Refurbishment works are typical for Grit Aeration Units #1 and #2

DATE BY WALKER PROCESS EQUIPMENT
 R1-SEWPCC Grit Aeration Unit
 Refurbishment Sheet 1
 CONTRACT 72-W06-BW/FILE 4534406-1

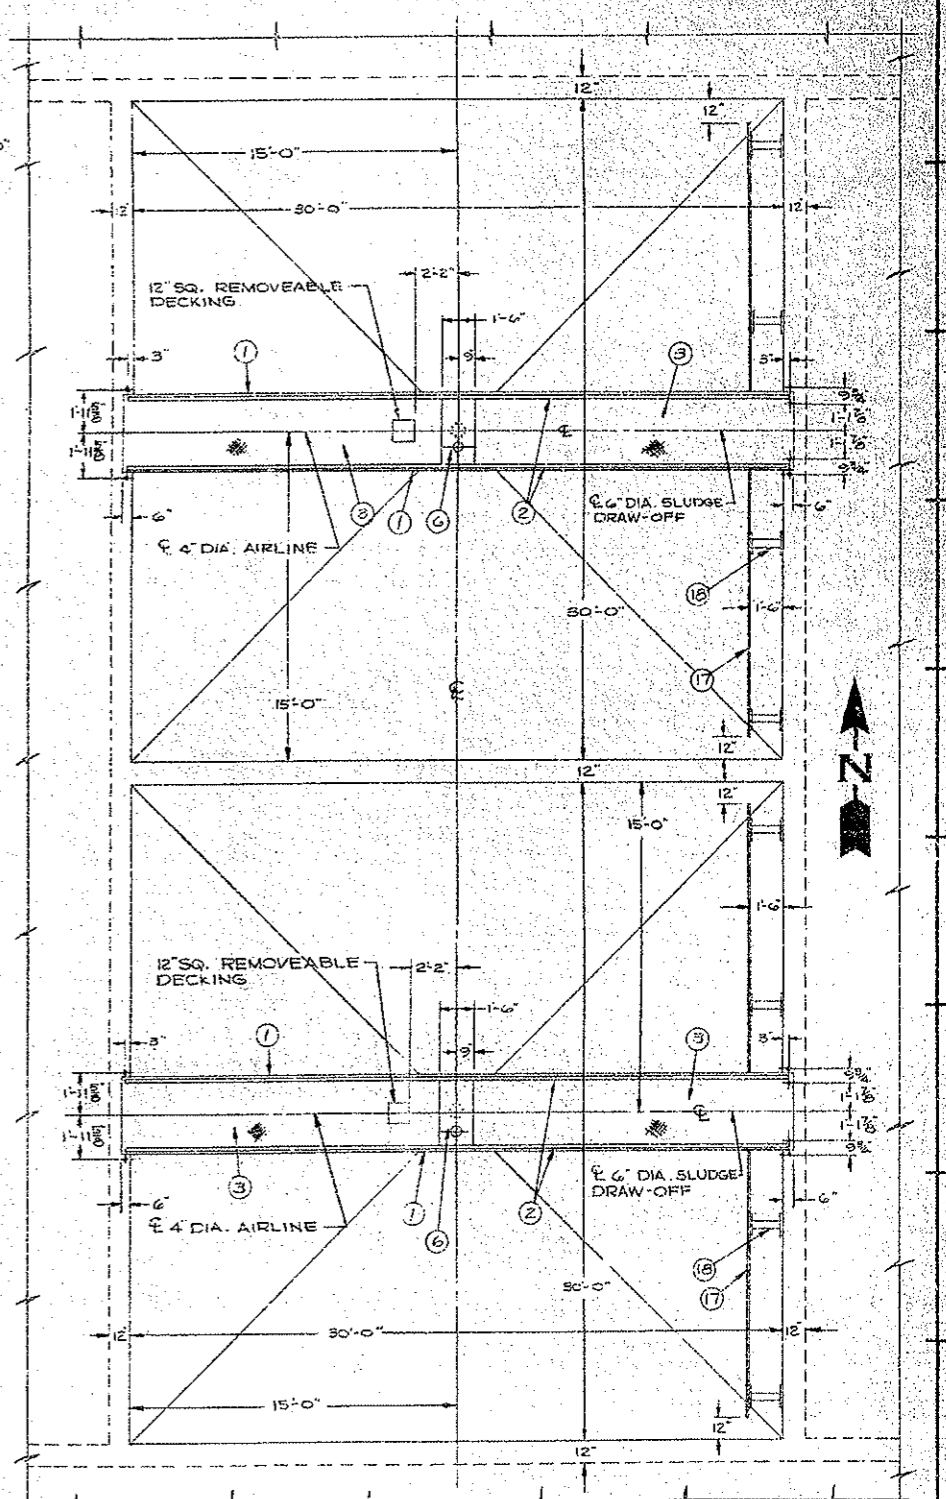
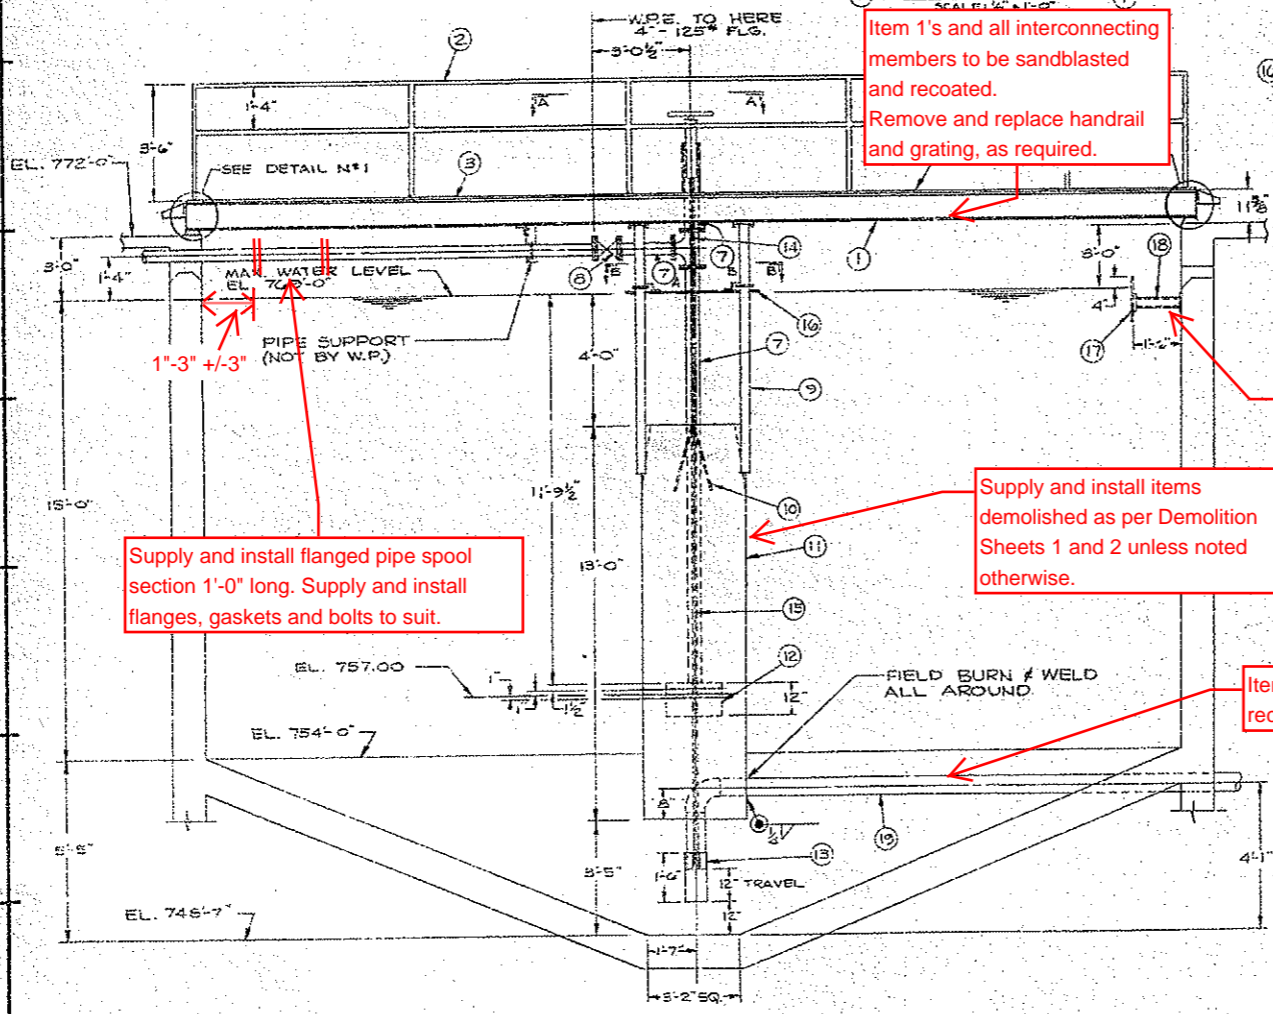
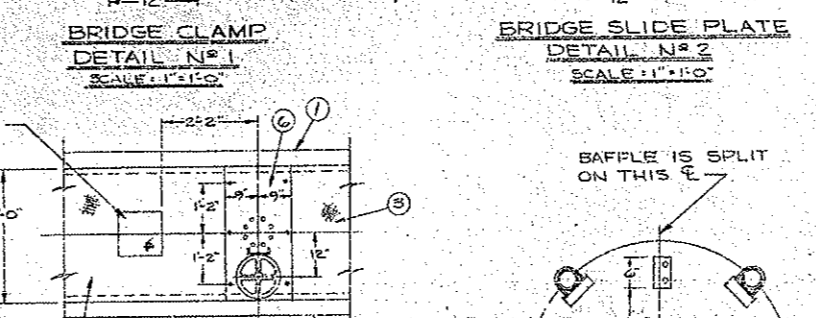
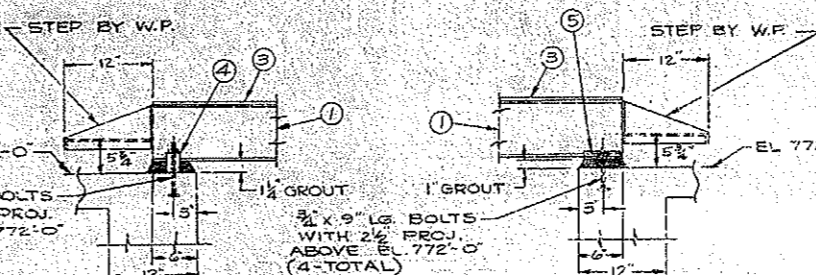
Item 1's and all interconnecting members to be sandblasted and recoated. Remove and replace handrail and grating, as required.

Items 17 and 18 to be sandblasted and recoated

Supply and install items demolished as per Demolition Sheets 1 and 2 unless noted otherwise.

Item 19 to be sandblasted and recoated

Supply and install flanged pipe spool section 1'-0" long. Supply and install flanges, gaskets and bolts to suit.
